### APPEAL SUMMARY

<b>Appeal ID:</b> 22233	<b>Project Address:</b> 729 SW 15th Ave
<b>Hearing Date:</b> 12/18/19	<b>Appellant Name:</b> Bashar Wali
<b>Case No.:</b> B-004	<b>Appellant Phone:</b> 503-295-2122
<b>Appeal Type:</b> Building	<b>Plans Examiner/Inspector:</b> Brian McCall
<b>Project Type:</b> commercial	<b>Stories:</b> 8 <b>Occupancy:</b> R-1 <b>Construction Type:</b> unknown
<b>Building/Business Name:</b> Hotel Deluxe	<b>Fire Sprinklers:</b> Yes - NFPA13 throughout
<b>Appeal Involves:</b> other: Occupant Safety Plan appeal	<b>LUR or Permit Application No.:</b> 19-126931-REV-01-CO
<b>Plan Submitted Option:</b> mail [File 1]	<b>Proposed use:</b> Hotel

## LIFE SAFETY CHECKSHEET

Application #: **19-126931-REV-01-CO**

# GROUND FLOOR OCCUPANCY SAFETY PLAN

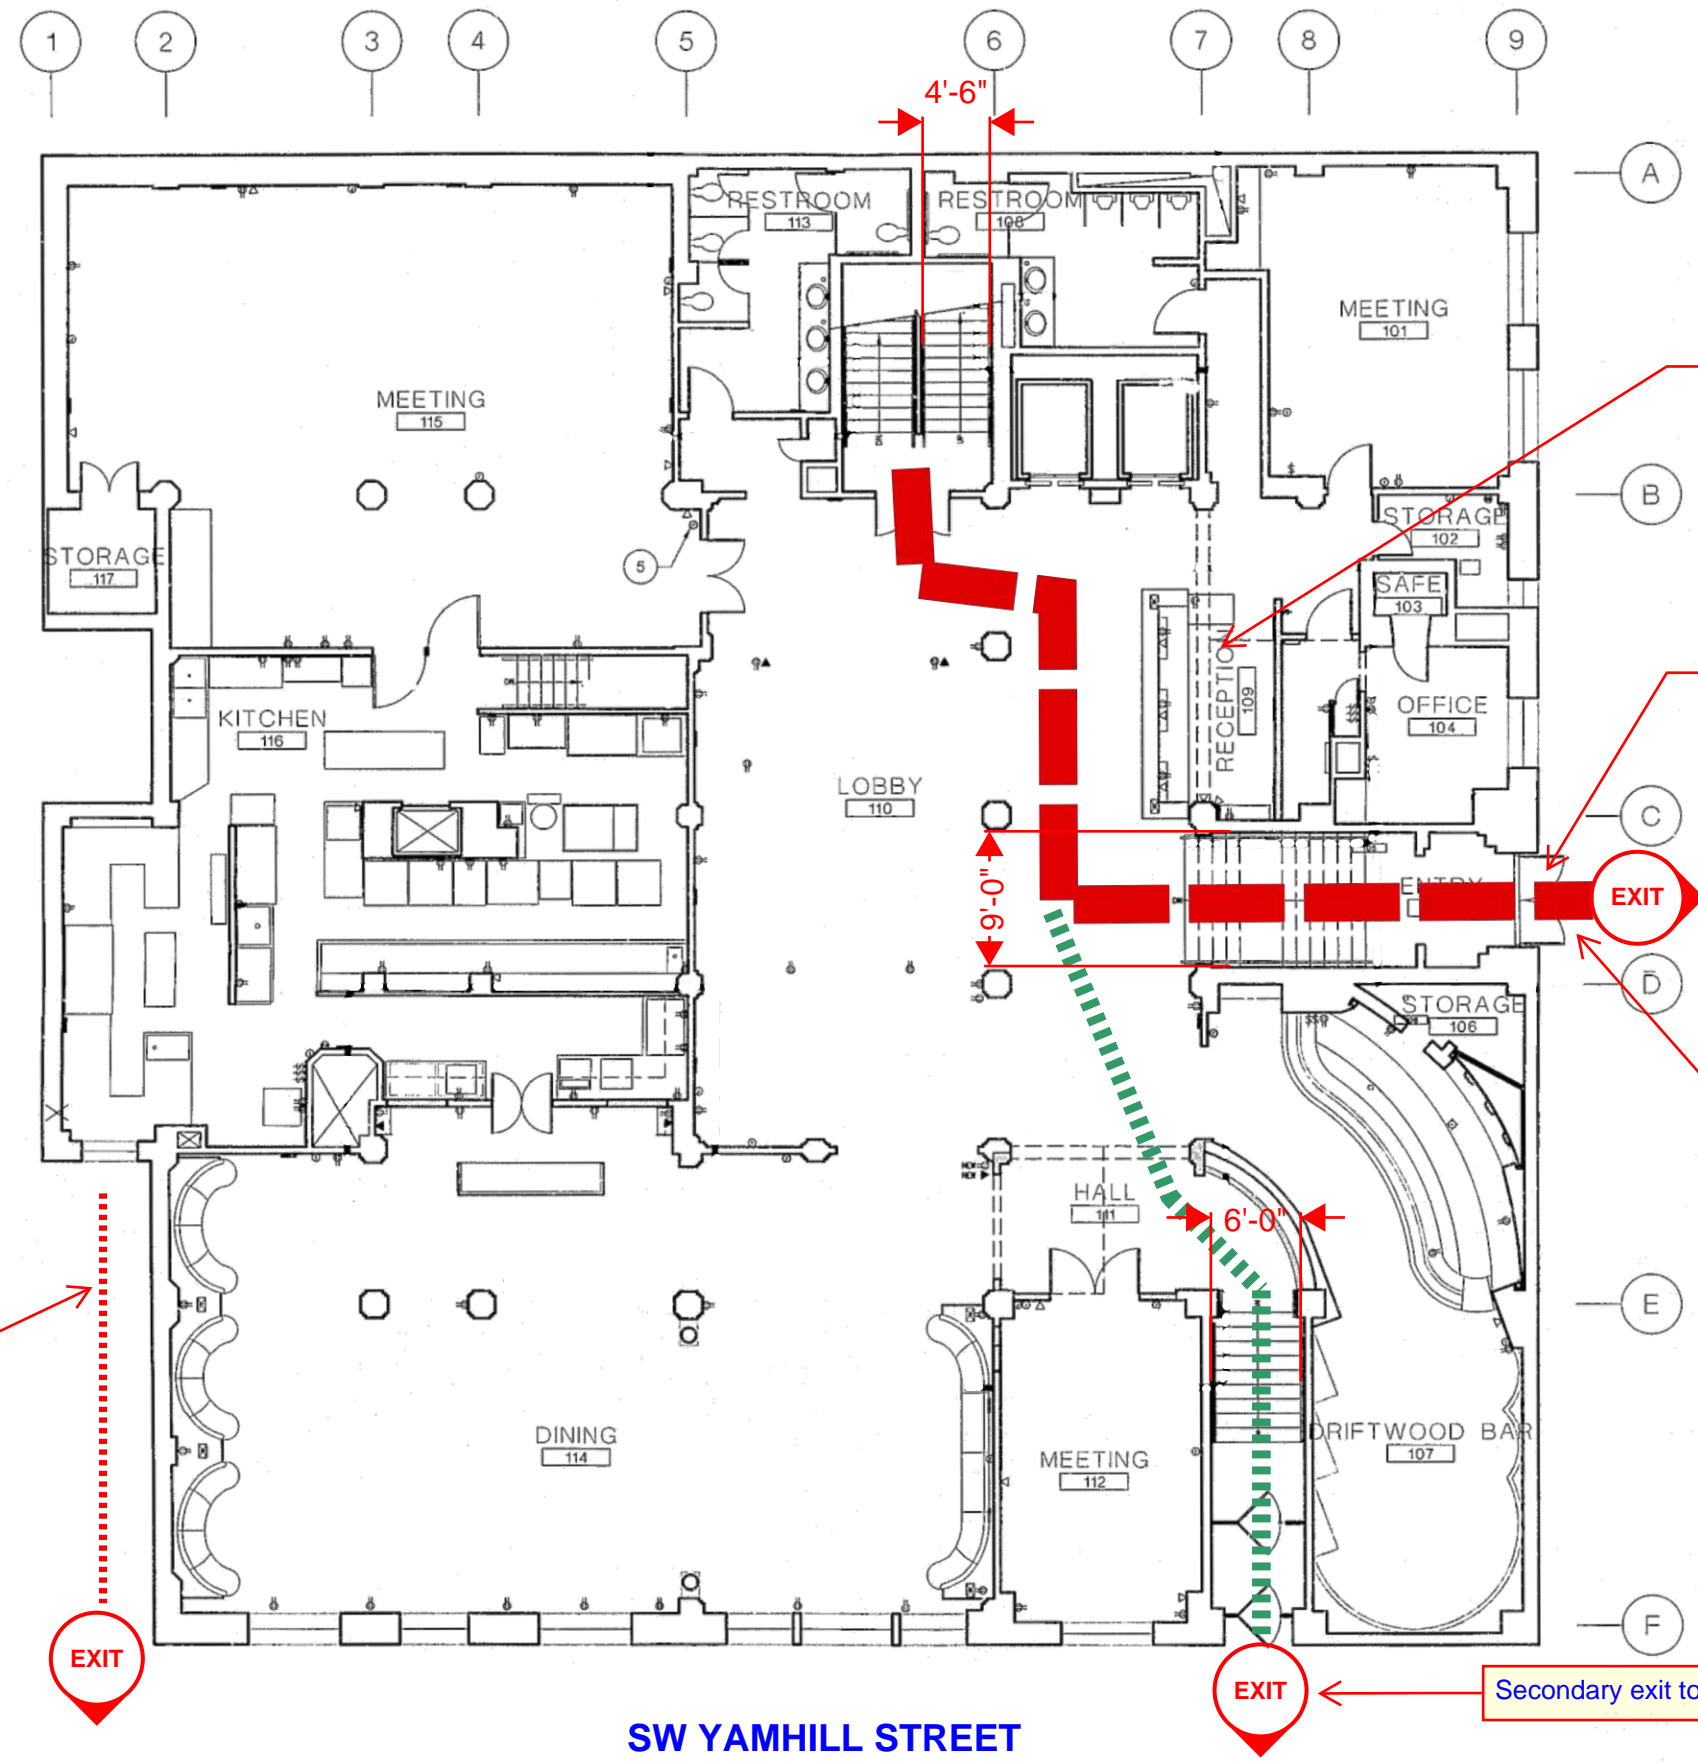
1.1			<ul style="list-style-type: none"><li>Due to work on the concrete floor of the East Fire Escape, how is exiting and entry through the lobby entrance protected from falling construction debris etc. above? Typically engineered scaffolding is provided to protect occupants.</li></ul>

1.4			<p>end condition created by work on East Fire Escape and the fact that service/exit stair does not connect directly to the first floor.</p> <ul style="list-style-type: none"> <li>• Add code summary info to plans, Occupancy Type, Construction Type, Number of stories, Sprinkler Type, Alarm Type, Occupant Loads, Stair Widths.</li> </ul>
-----	--	--	---

Checksheet item number	Description of changes, corrections, additions, etc.	Location on plans
1.0	Building code appeal applied for.	
1.1	Protection from falling debris : The East fire escape terminates at the second floor. The second floor is concrete. In addition the lobby entrance has a steel canopy over the exterior walkway approximately 12 feet wide and projecting approximately 8 feet from the lobby door. These existing features provide protection for pedestrians at the street level. In addition, the contractor will provide a protection barrier at the exterior [open] side of the fire escape to prevent materials, debris, or dust from falling to levels below.	OSP item 6.2.3

1.4	Code summary added. Occupant loads & stair width shown on plans. R-1 occupancy, I-A construction, 8 stories, NFPA-13 sprinklers, alarms as required by FM 41 agreement.	Code summary – drawing page 1 Occupant load – below drawing title Stair width dimensions on plan

## FLOORS 3 thru 8 OCCUPANCY SAFETY PLAN

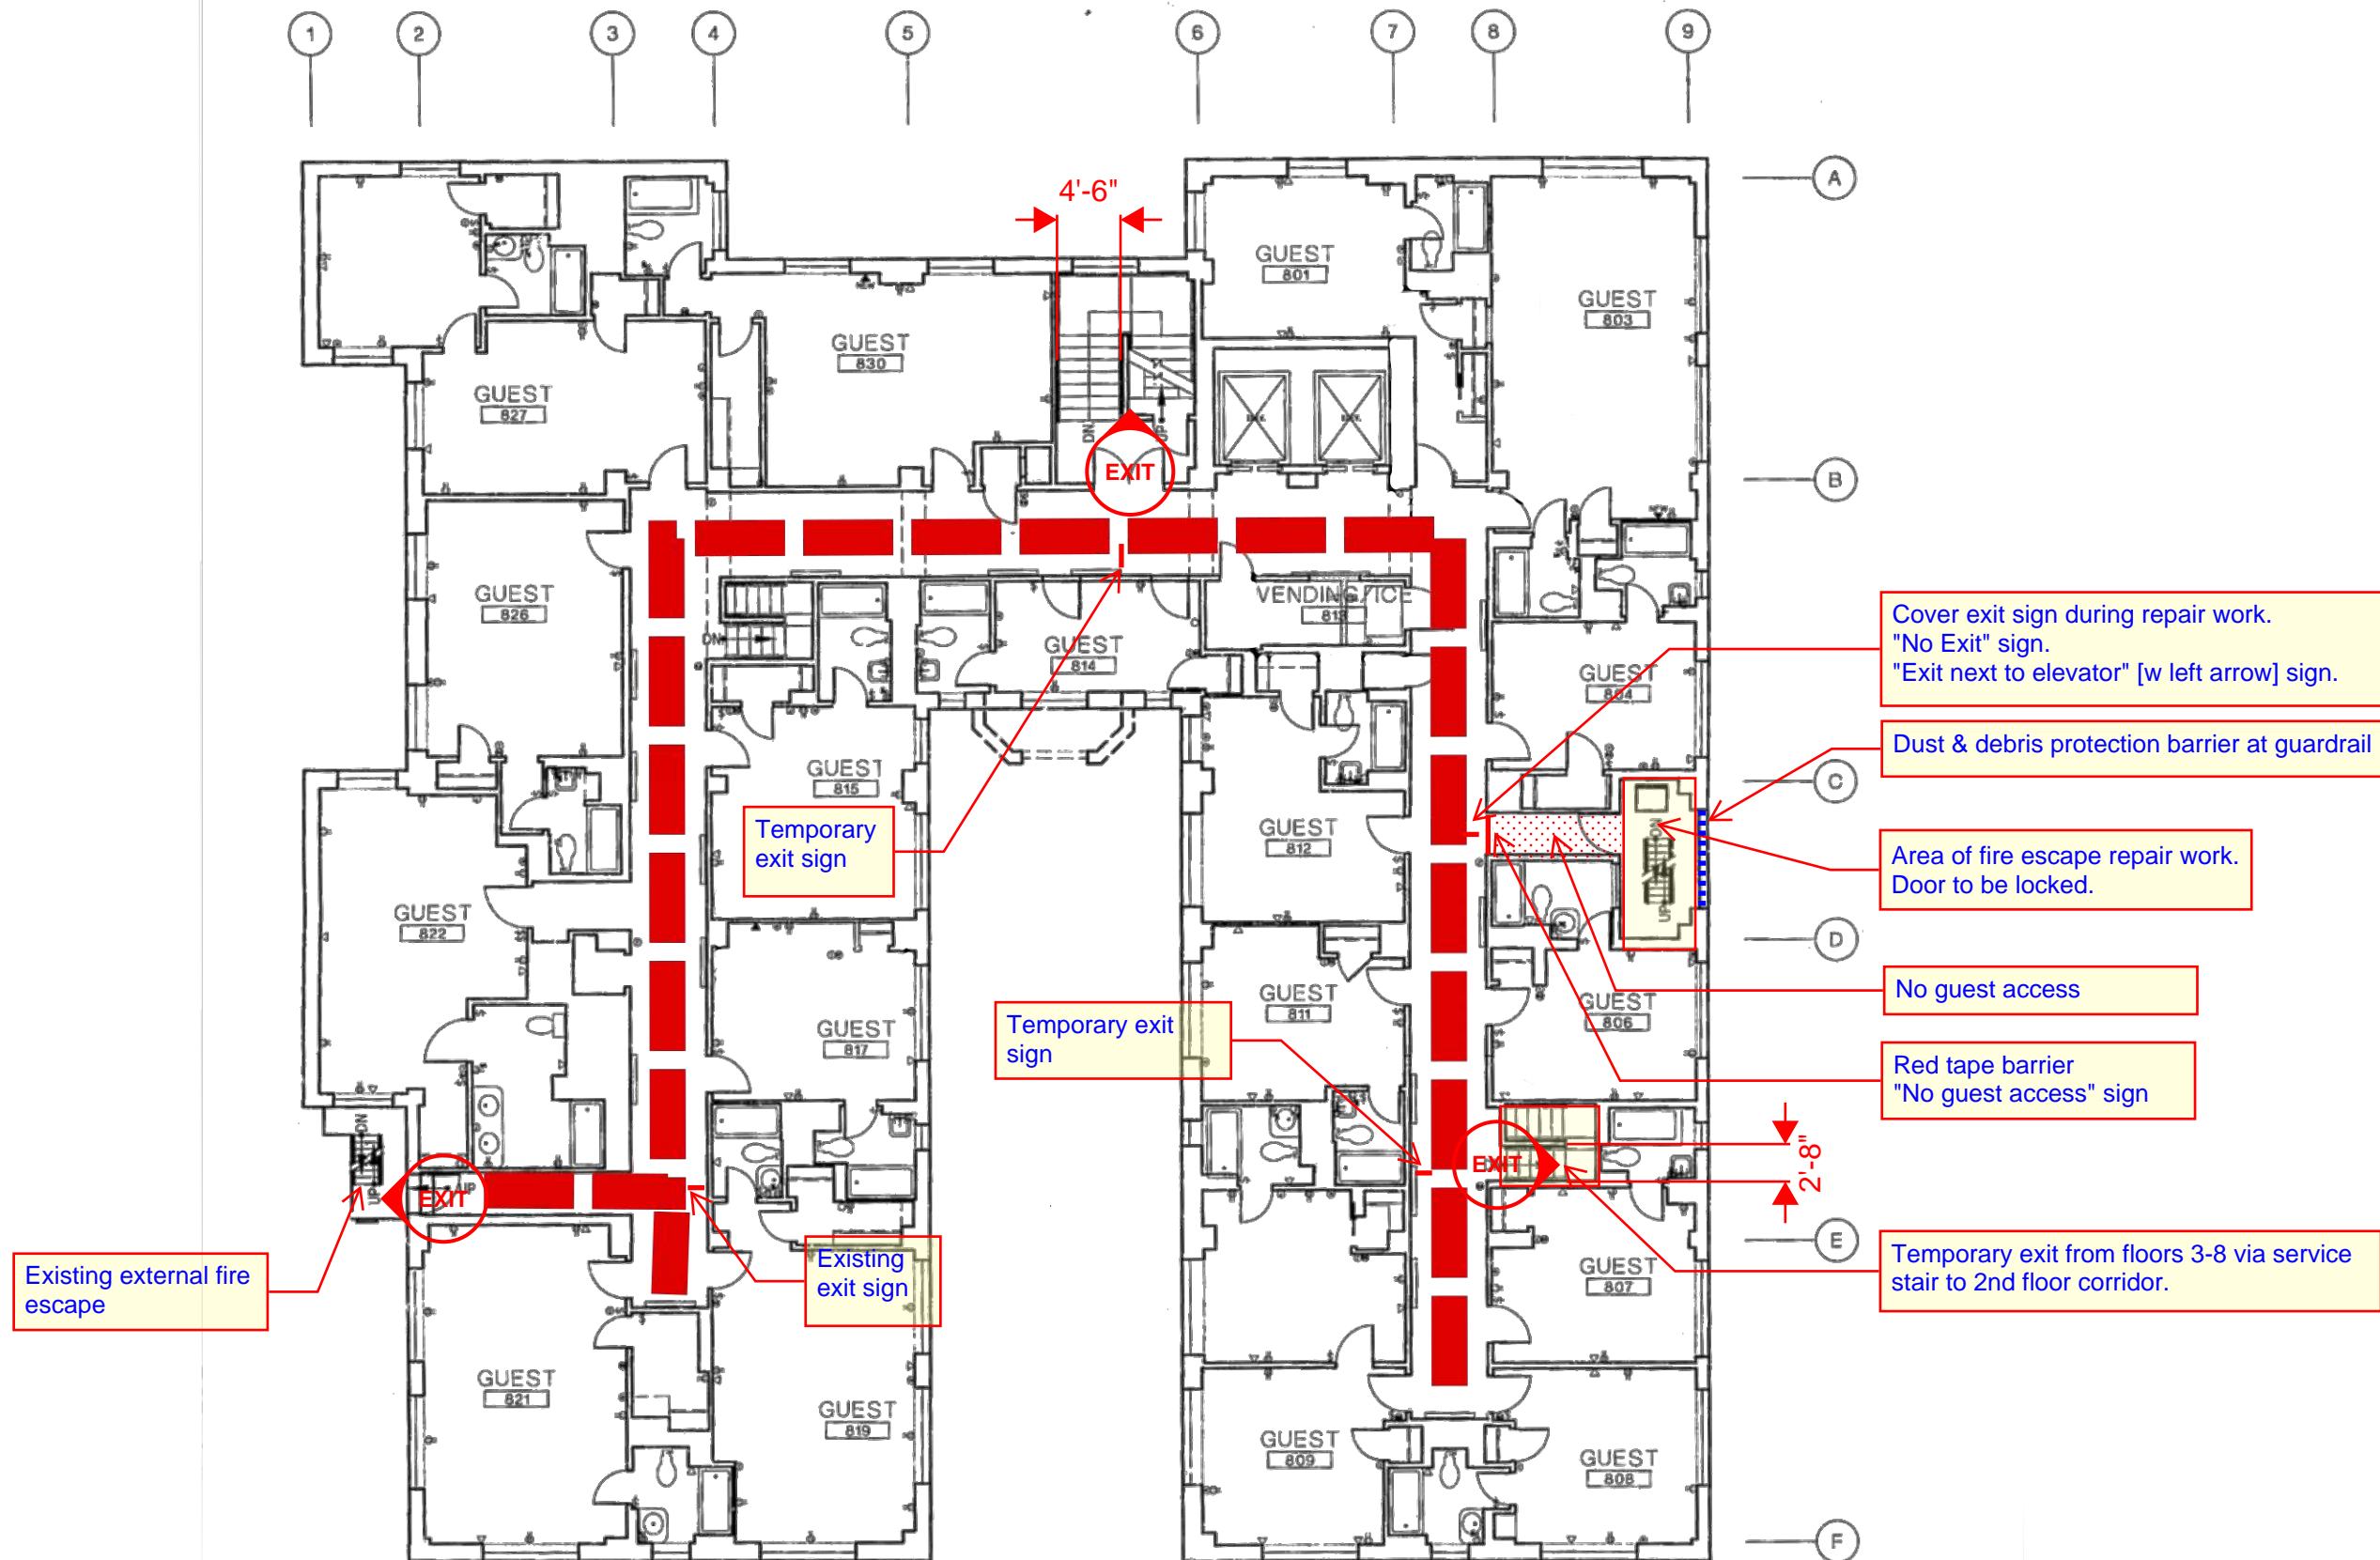
1.2			<ul style="list-style-type: none"><li>Service stair that is proposed to serve as an Exit from floors 8-3. Does it comply as an exit stair per 1022? Clarify compliance and deficiencies. Is it smoke proof?</li></ul>

1.3			<ul style="list-style-type: none"><li>On the east wing of level 2 notate travel distances, and address dead</li></ul>

1.2	East service stair : The existing service stair does not comply with OSSC 1022. The stair is not smoke proof. There is a door at every level at the bottom of the stair run going up to the next level. The stair run down does not have a door. Therefore each stair is open to the level immediately below it, but not to levels above. The door does not have smoke seals. The width of the stair is approximately 32". A handrail is provided on one side of the stair. Handrail extensions are not provided. Location of the door to the stair encroaches into required landing.

1.3	Added travel distances and dead end corridor length. Revised proposed exiting to provide emergency exit on 2 <sup>nd</sup> floor through window at guestroom [temporarily converting guestroom as noted on plan.	drawing page 2
